Title: Advisory Committee on Reactor Safeguards  
US EPR DCD Subcommittee

Date: Wednesday, March 3, 2010

SUBCOMMITTEE ON THE US EPR DCD

9 Consistent with what we have done with the  
10 other chapters, our objective here today is to provide  
11 a summary level presentation of the organization and  
12 material in Chapter 4 of the U.S. EPR FSAR. The focus  
13 of the presentation, again consistent with other  
14 presentations that we have given is on those features  
15 or analytical methods or modes of operation which may  
16 be unique to US EPR.

# Chapter 4, Reactor: 4.4 Thermal-Hydraulic Design Aeroball Measurement System

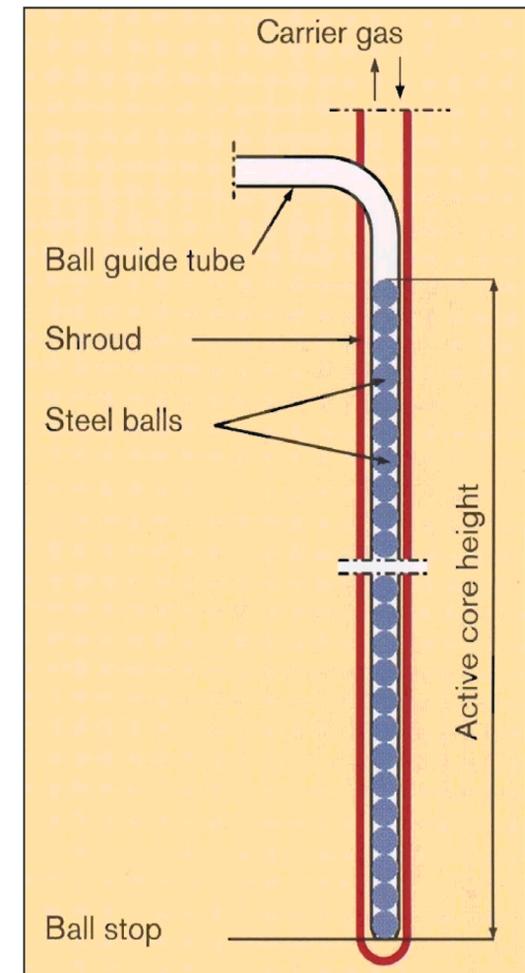
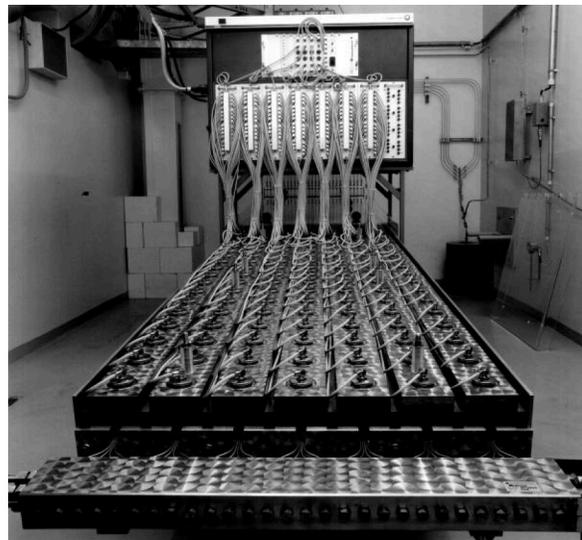
18 The carrier gas tubes, if you look on the  
19 right side of your slide there, the carrier gas tubes  
20 are the reactor coolant system pressure boundary. Is  
21 that correct?

14 Okay, so to answer your question, you are  
15 asking if the carrier gas tube is the pressure  
16 boundary. Is that correct?

18 MEMBER STETKAR: Right, which is on this  
19 drawing. The red deal.

5 MS. SLOAN: We will send a better figure.  
6 We will send it through --
